## PLANNING REPORT

# Architectural Review Board

## 55 S. RIVERVIEW STREET 23-102INF

Address	55 S. Riverview St, Dublin, OH 43017
Proposal	Informal review and feedback for a rear addition to an existing two-story building in the Historic District.
Request	This is a request for non-binding review and feedback of a future development application.
Zoning	HD-HR, Historic Residential District
Planning Recommendation	<u>Consideration of the Discussion Questions</u>
Next Steps	Subsequent to informal review and feedback, the applicant may apply for a Minor Project to be considered by the Architectural Review Board (ARB).
Applicant	Michael and Angela Kne, Owners Dominic Luppino, CPBD, Residential Designed Solutions
Case Manager	Sarah Tresouthick Holt, AICP, ASLA , Senior Planner 614.410.4662 <a href="mailto:sholt@dublin.oh.us">sholt@dublin.oh.us</a>

### North Elevation

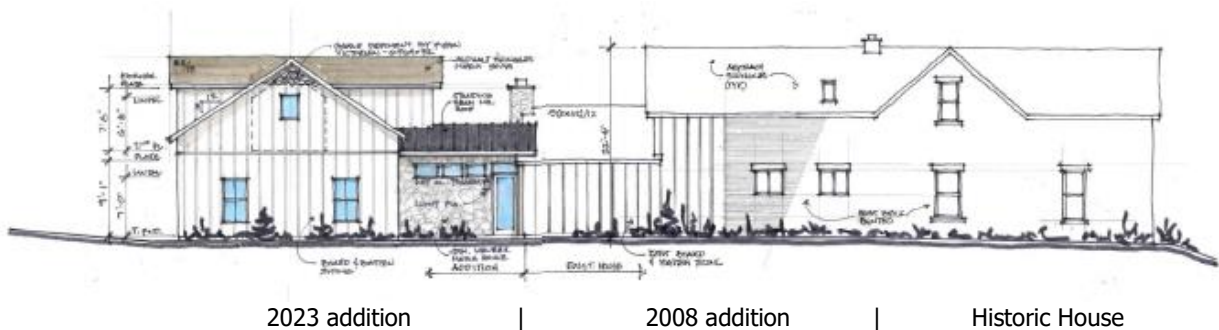
This elevation faces Spring Mill Lane and indicates the deep hyphen reveal. Gable roof forms are used for the addition, with roof pitches meeting Code Section 153.174(B)(4)(c)(1). Window placement is symmetrical and regular, as recommended in Guidelines Section 5.6A. Board-and-batten is shown on the majority of the addition, and stone veneer to match the chimney is shown on the hyphen. A gable decoration made of Fypon is proposed; this would require a Waiver for the use of the material. The Board is asked to comment on the appropriateness of this detail; it is intended to mimic the detail on the existing front porch.
